Kewaunee Nuclear Power Plant
 N490, State Highway 42
 Kewaunee, WI 54216-9511
 920-388-2560

DOCKET 50-305
 OPERATING LICENSE DPR-43
 KEWAUNEE NUCLEAR POWER PLANT
NUCLEAR MANAGEMENT COMPANY, LLC. RESPONSE TO NRC 'S REQUEST FOR
 ADDITIONAL INFORMATION ON WISCONSIN PUBLIC SERVICE CORPORATION
 RELOAD SAFETY EVALUATION METHODS TOPICAL REPORT, WPSRSEM-NP,
 REVISION 3

Response to NRC Questions Concerning Reload Safety Evaluation Methods

Figure 5 – CE Test Rig RETRAN Noding Diagram
(not to scale)

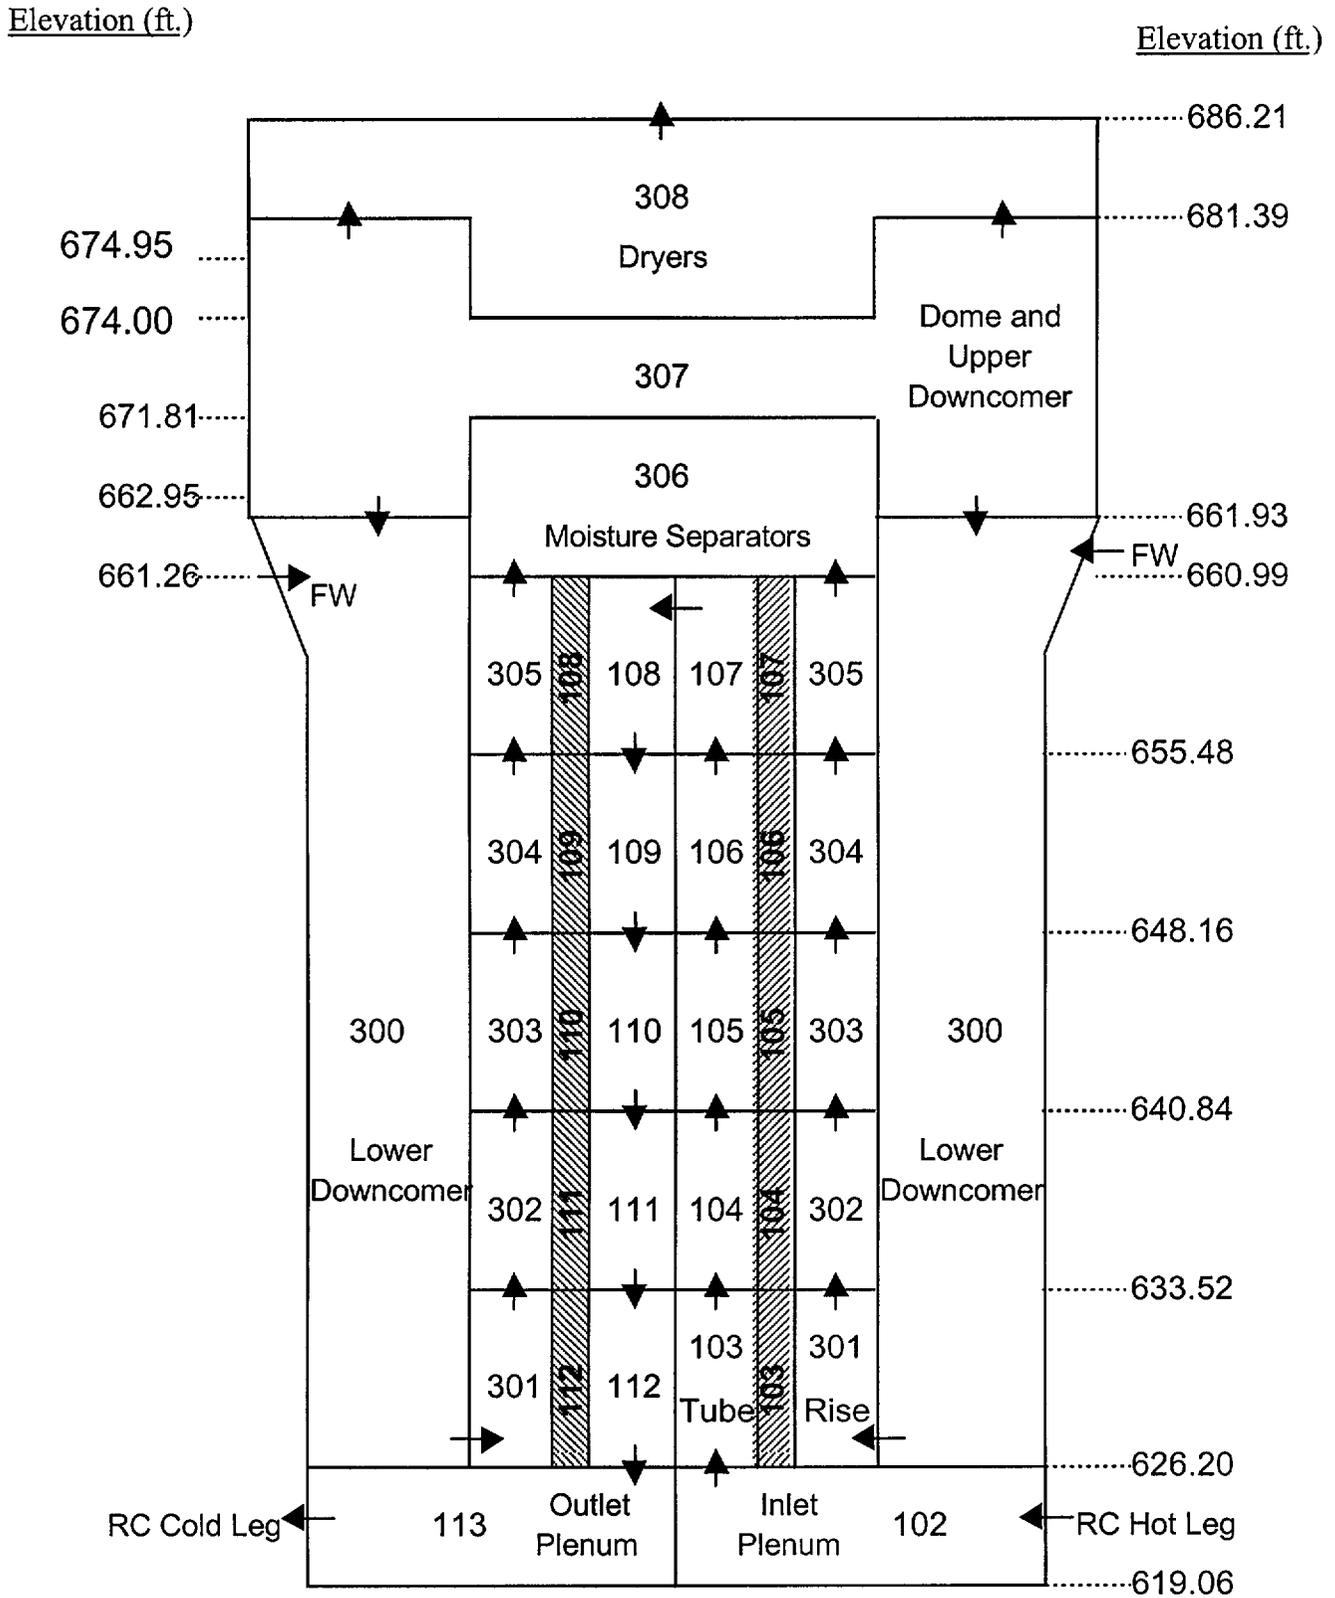
2.3.2 *A drawing showing the RETRAN 3-D steam generator noding used for the experiment(s) and the Kewaunee steam generator*

Figure 5 and 6 show the RETRAN-3D model steam generator noding used for the experiments and for KNPP steam generator respectively.
